Service Bulletin

PRELIMINARY INFORMATION

Subject: SES MIL DTC P0442

Models: 2010 - 2012 Buick LaCrosse
Equipped with 3.0L (RPO LF1) or 3.6L (RPO LLT)

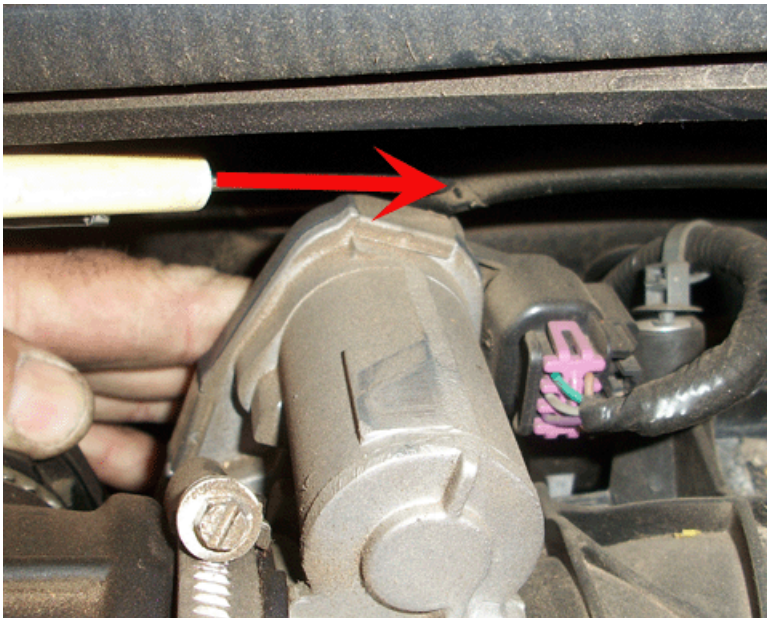
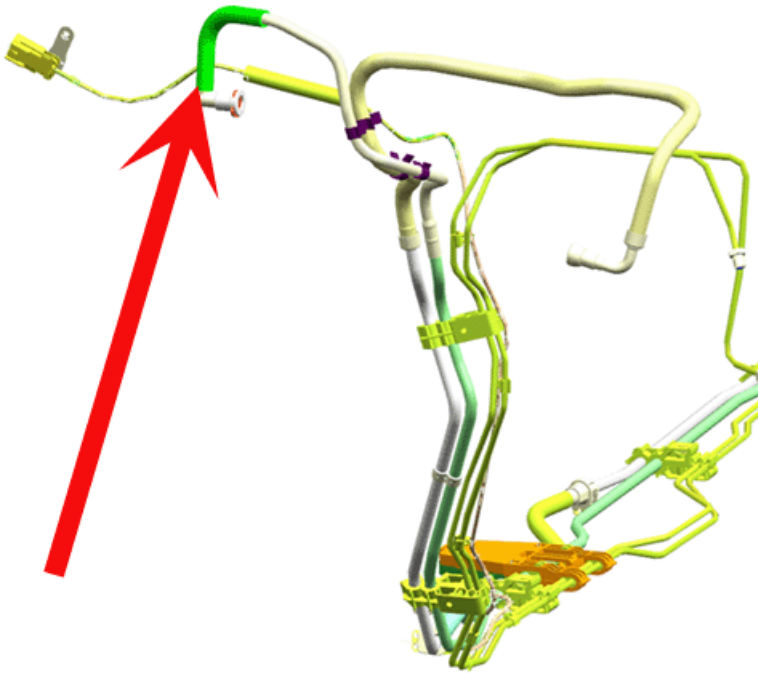
SES MIL illuminated with a DTC P0442 setting.

Visually inspect evaporative pipe for contact with the throttle body. If contact is present, replace the evaporative pipe as needed and secure to eliminate future contact. Clear DTCs.

Note: The new evaporative pipe will have a conduit installed in the area of concern of the original pipe. Reference photos below.
